VDS240 Wireless Vehicle Detection System

RTMS Echo - Release 2.4.0.134

Release Notes

Update Echo GUI with Sensys branding [15405]

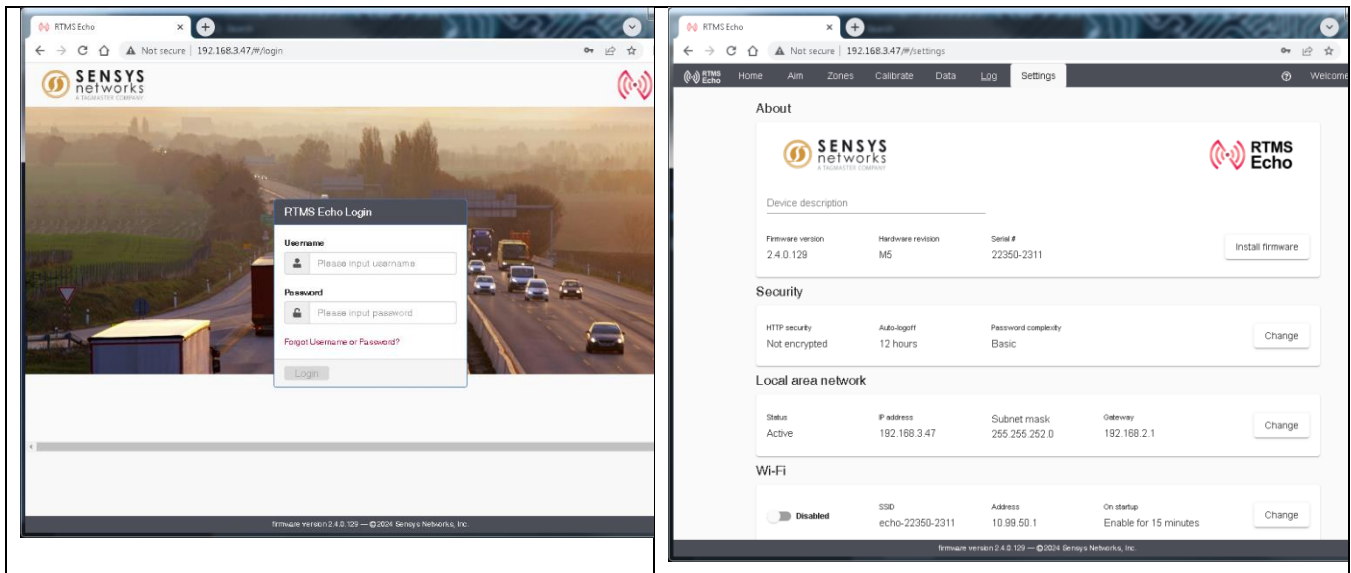
RTMS Echo web GUI has been updated with Sensys Networks branding. Below screenshots show login screen and the settings screen.

Hide license section in GUI [15431]

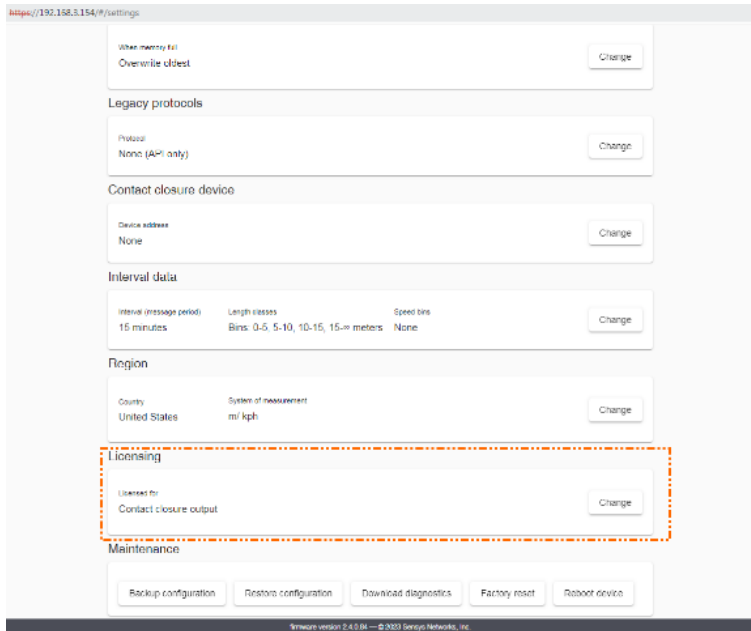
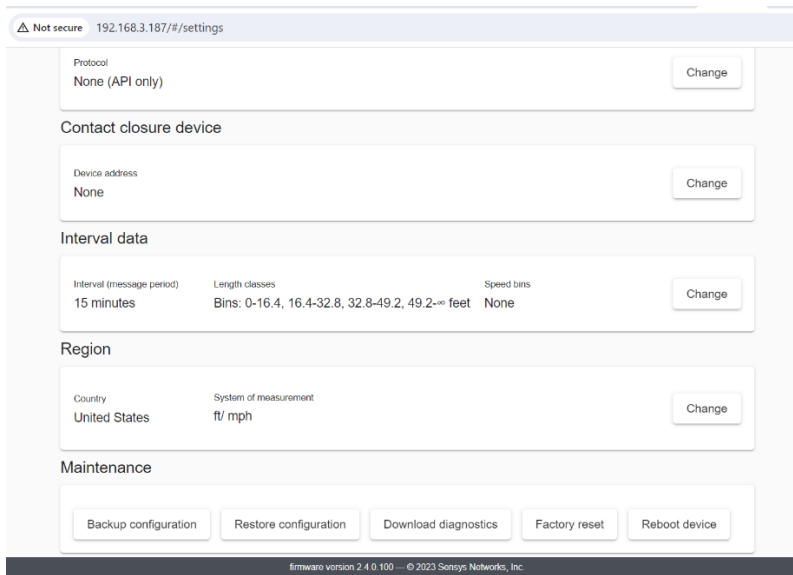
A license section appeared in the ECHO GUI that expected user to input license information for contact closure device as below:

This has been updated and a license screen no longer appears. The new screenshot is pasted below:
